**NSLPP MEETING HELD ON 02/08/2023****Attachments:**

ADDRESS/WARD: 4 Warung Street, McMahons Point**APPLICATION No:** DA 235/2022

PROPOSAL: Alterations and additions to an existing dwelling house, including internal reconfigurations, a rear addition on the first and second floor levels, and associated works.

Figure 15. Excerpt from Section B to demonstrate height variations

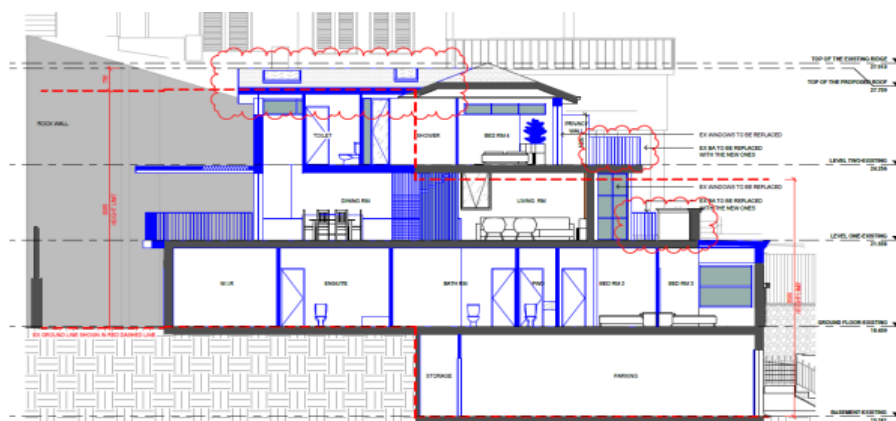
The extent of the proposed variations is identified in the table below, referencing the diagram in Figure 15 further below. The proposed rear addition on the second floor level has a maximum building height of 9.29m, being a variation of 790mm or 9.2%. The lateral extent of the variation relates to the whole of the rear roof's central gabled form. The existing top floor level and roof form at the front of the dwelling which are proposed to be altered under the proposal also do not comply with the development standard, having a maximum building height of 12.67m, being a variation of 4.17m or 49%.

Non-compliance Building Element	Control	Height	Variation
Existing front roof and southern ridgeline (front elevation)	8.5m	12.67m	4.17m (49%)
Privacy screen on the first floor level		9.1m	0.6m (7.5%)
Balustrade on the second floor level		10.8m	2.3m (27%)
Rear northern ridgeline and roof form		9.29m	0.79m (9.2%)

2 LEVEL ONE PLAN-PROPOSED

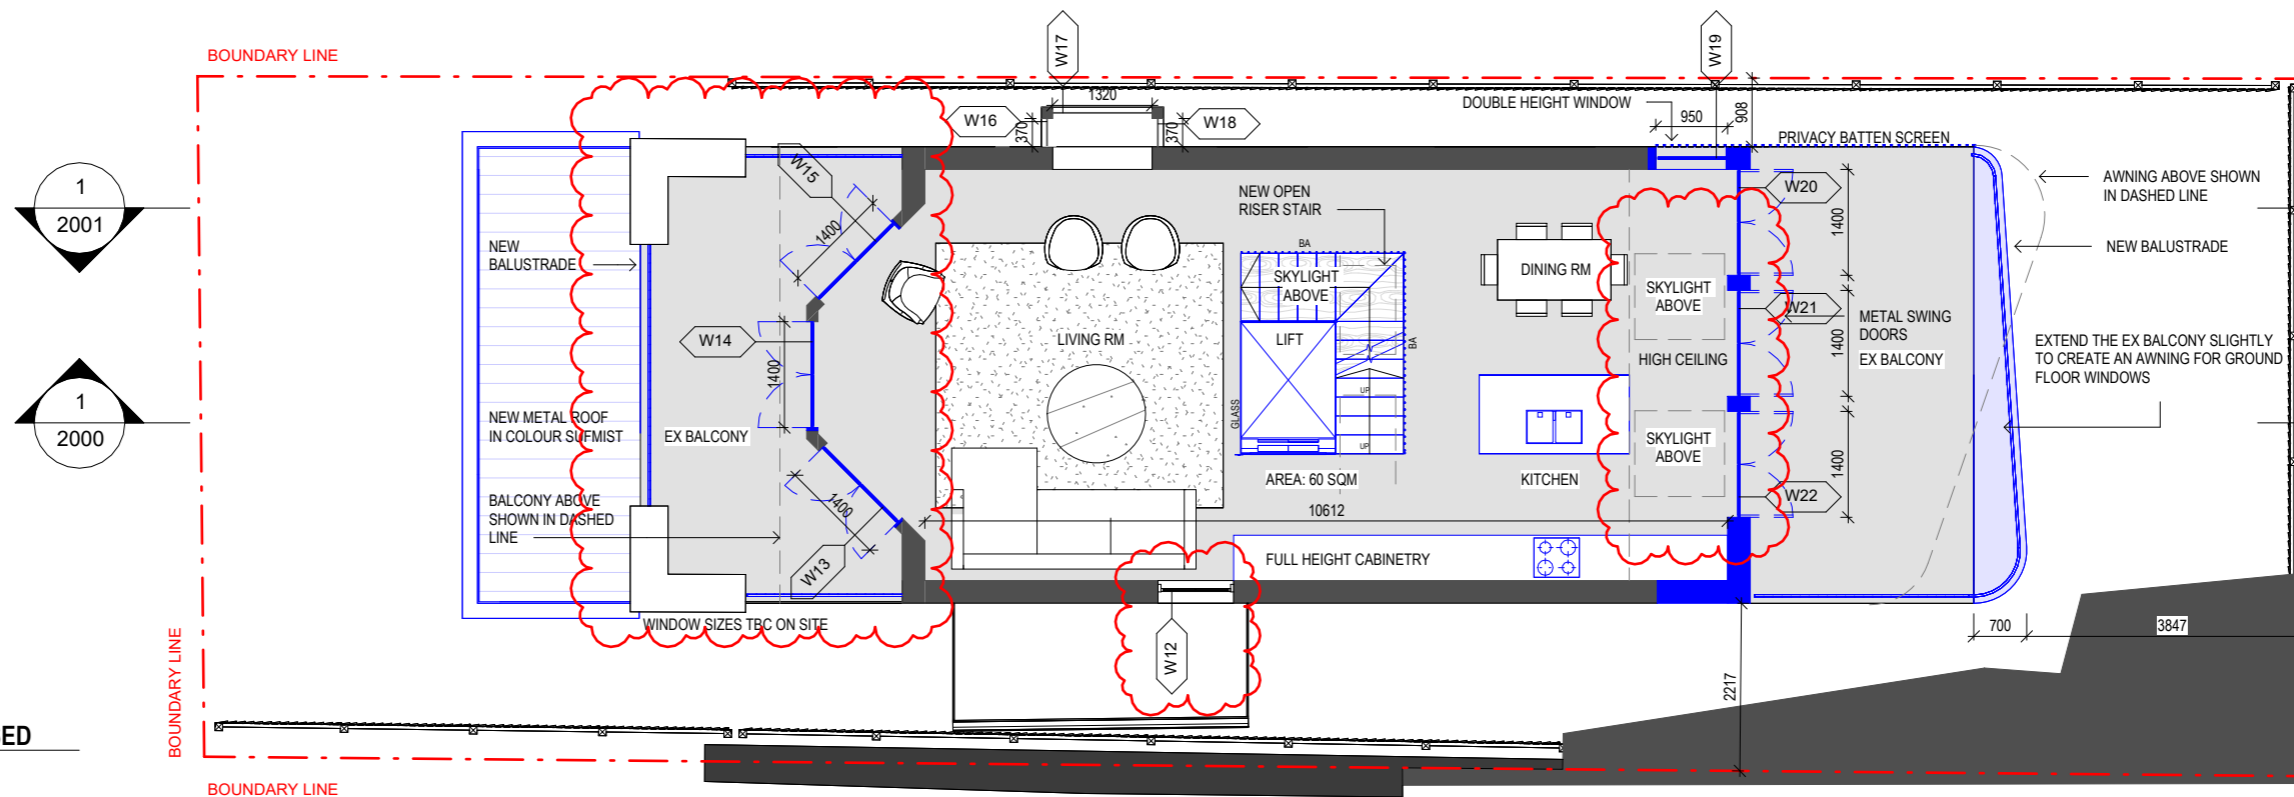
- *Concerns are raised regarding privacy impacts, including overlooking into the skylights of a bedroom from windows W19 and W27.*
- *The first floor level balcony extension would cause overlook the adjoining courtyard.*
- *Proposal should be modified to prevent any loss of privacy.*

- (a) Window W19 on the western elevation of the first floor level (Dwg 1102 Level One Floor Plan by Superdraft Australia Pty Ltd, Revision B, dated 17/05/2023) must be fitted with obscure or frosted glazing and the opening aperture is to be limited to 100mm to still allow ventilation whilst retaining privacy between the subject dwelling and the adjoining property to the west.

Given that the site orientated on a north-south axis it is evident that the majority of the overshadowing will fall within Warung Street and there will be minimal overshadowing of adjoining dwellings. The overshadowing to the front portion of the eastern roof plane of No.2 Warung Street occurs at 9am only. Window W27 is a highlight window and therefore will not create any privacy impacts.
